EA Project No.: 16-1100

DATE OF ISSUANCE: February 14, 2017

Notice: This addendum is issued to all prospective bidders as an amendment to the Drawings and Project Manual for the Canopy Row. Bidders shall acknowledge this addendum on the Bid Form. All information contained herein shall be fully incorporated into the Contract Documents as though originally included therein.

M300

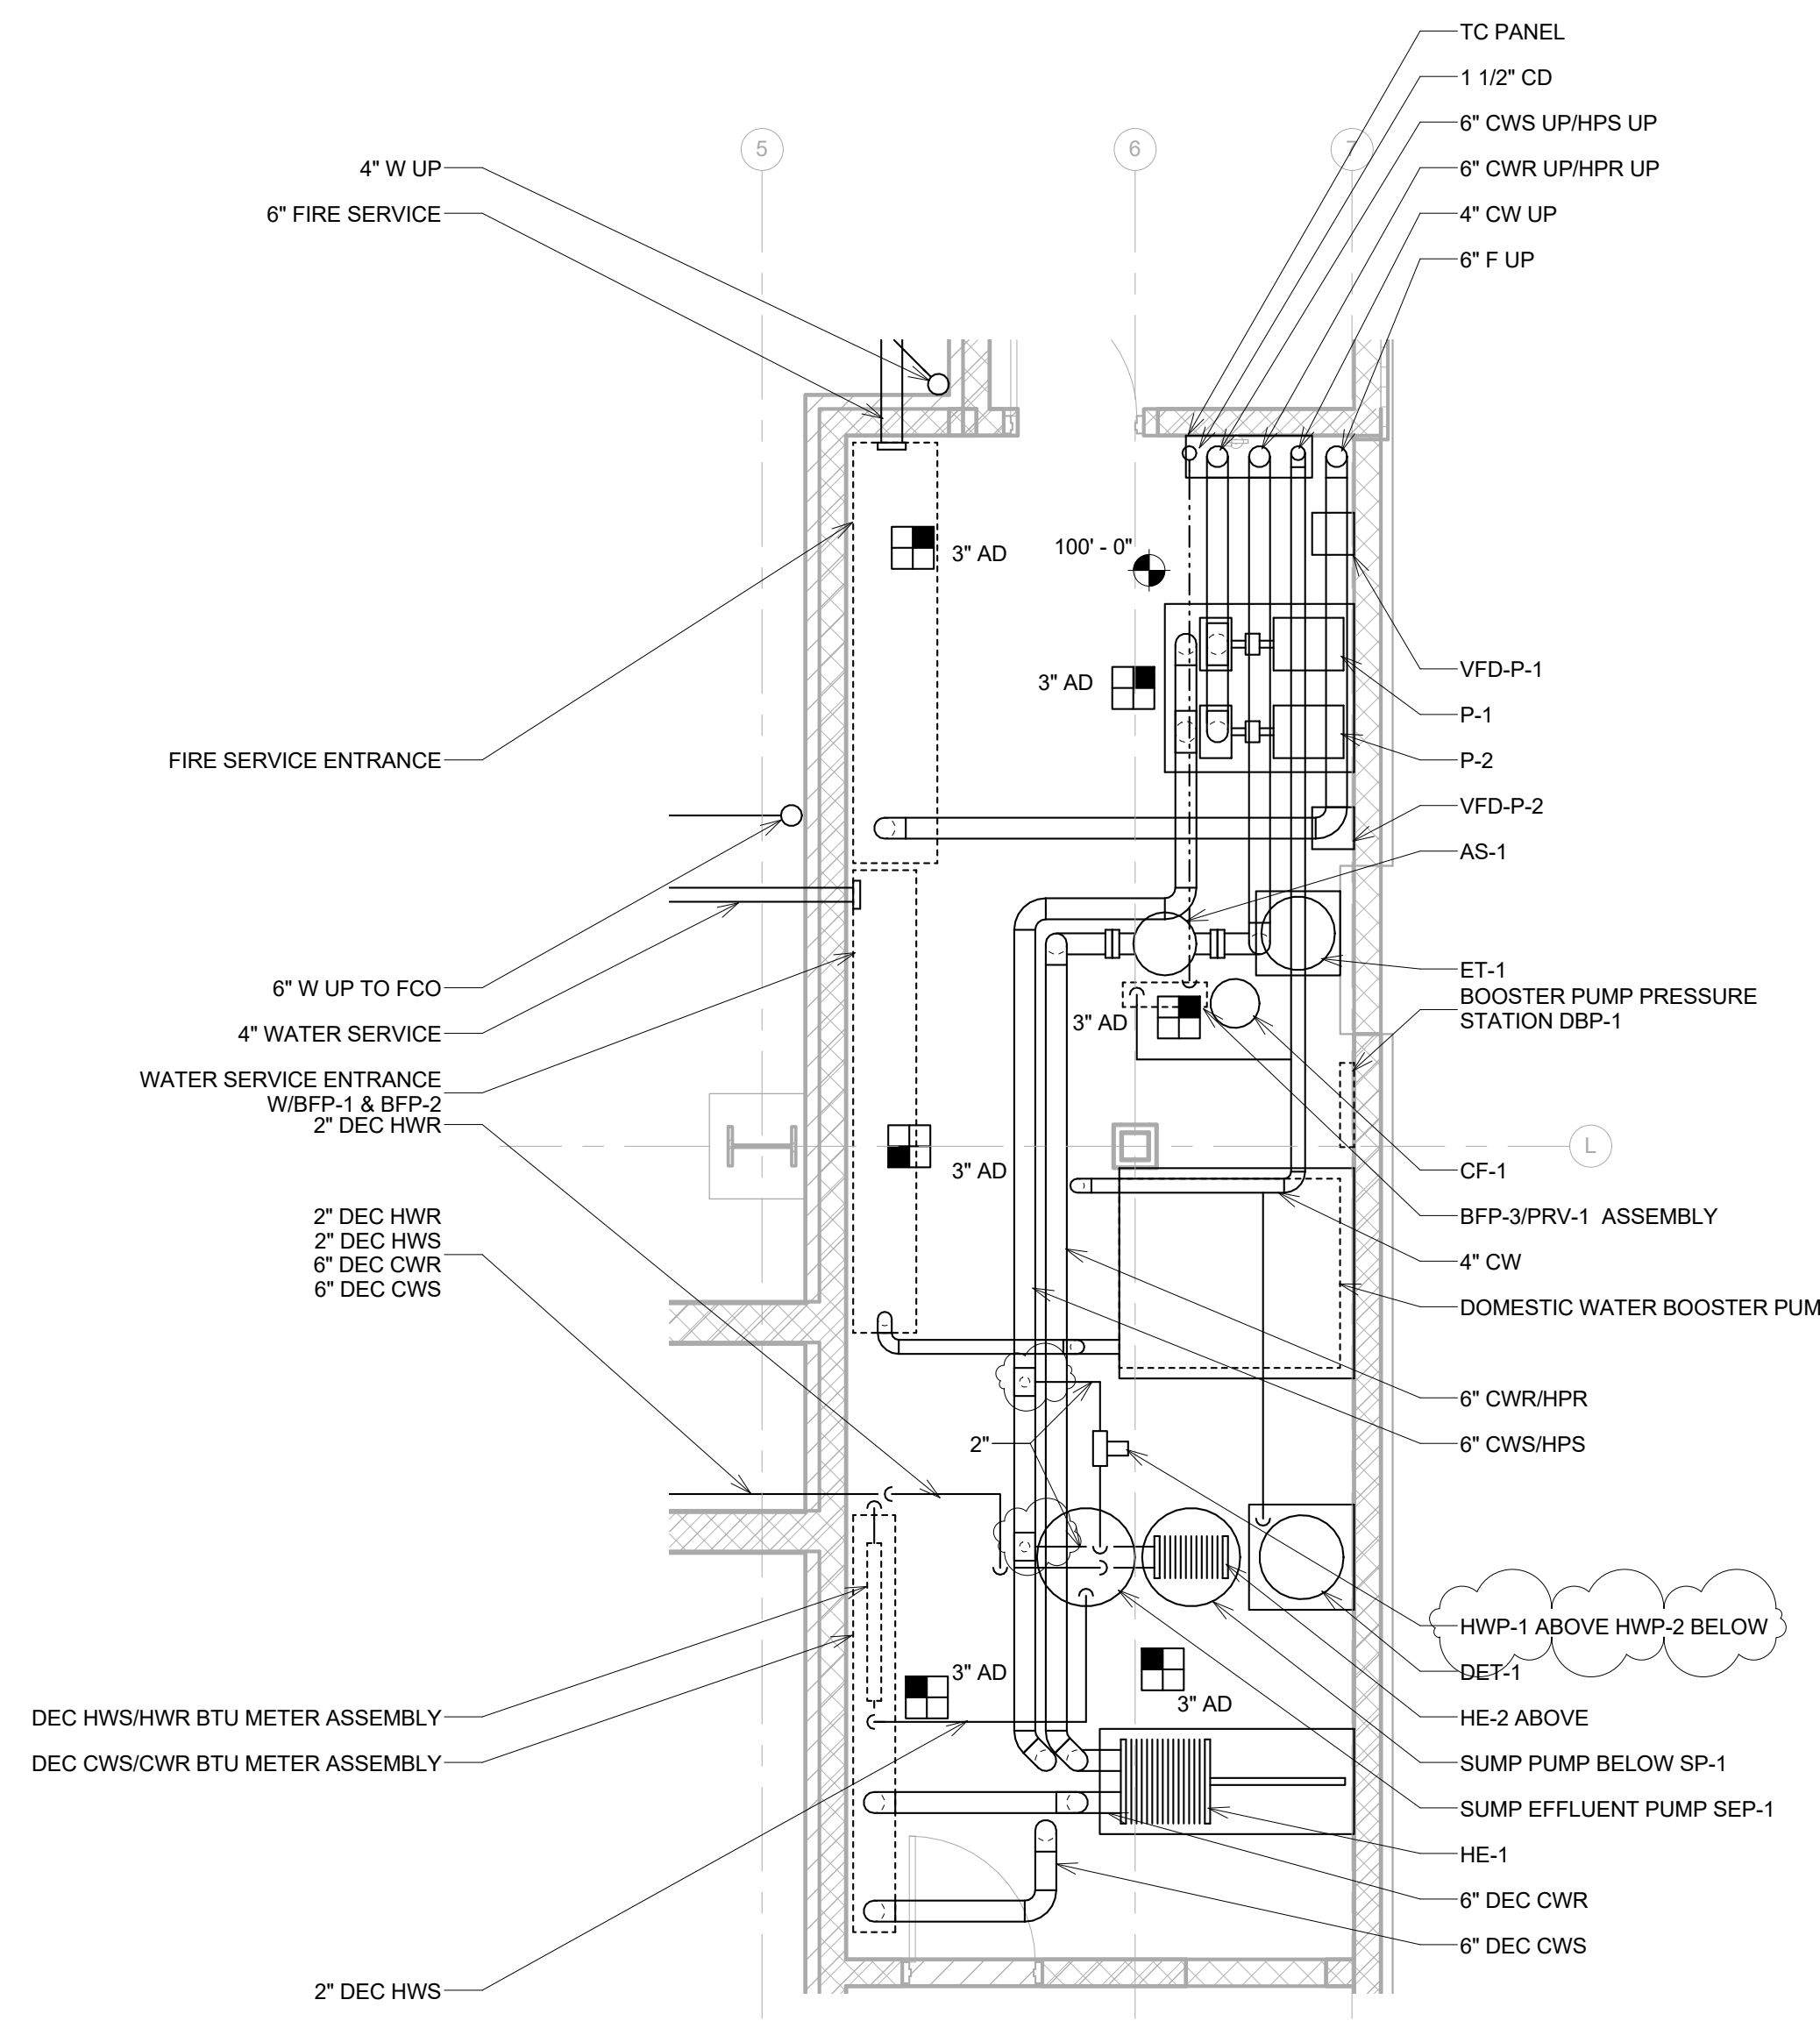
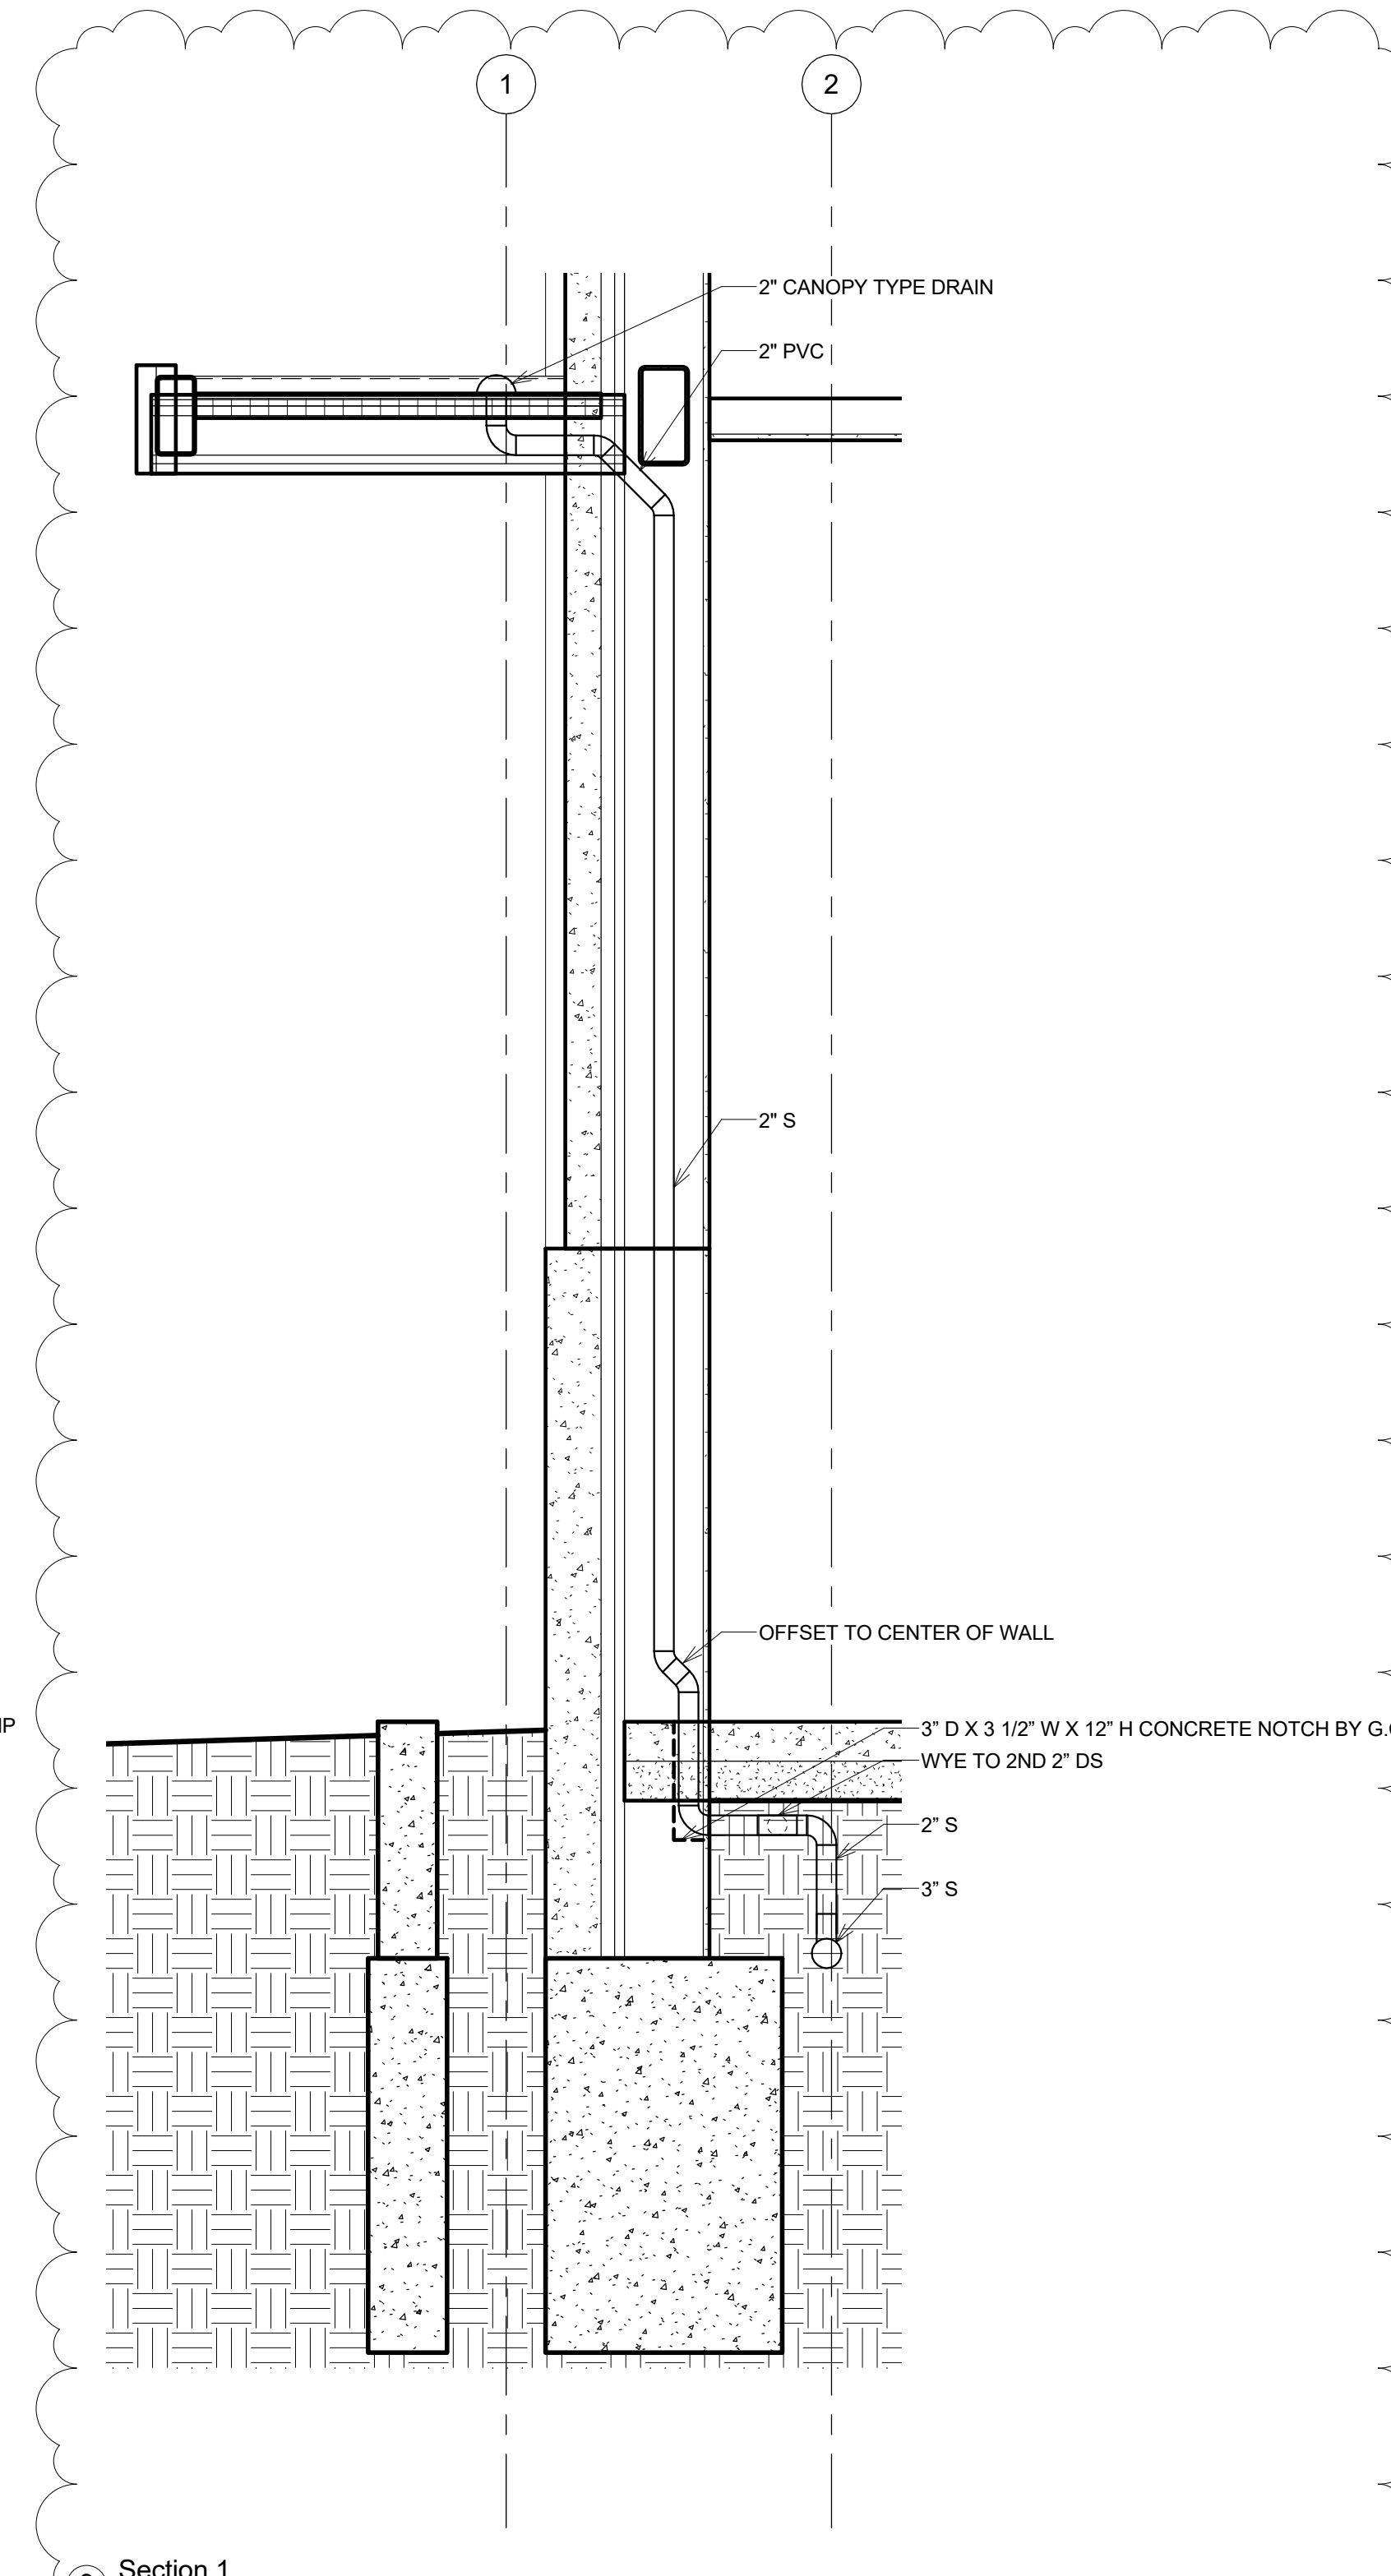
Reference Revised Sheet M300

Add second HWP-2 to be installed below HWP-1 and change piping connection of HE-2 from upstream of HE-1 to downstream of HE-1.

Add section showing the pipe routing of the 2" roof drains in the canopy over Vestibule 101 entrance to the under floor 3" storm.

ENLARGED VIEWS
ADDENDUM 2: CHANGE NOTE TO "HWP-1 ABOVE HWP-2 BELOW" WAS "HWP-1" IN
DETAIL 2 (LOWER LEVEL PLUMBING - CALLOUT 1) REVISE HE-2 PIPING FROM UPSTREAM
OF HE-1 TO DOWNSTREAM OF HE-1 IN DETAIL 2. ADD DETAIL 3 FOR SECTION OF 2" RD
GOING DOWN WALL IN VESTIBULE B101
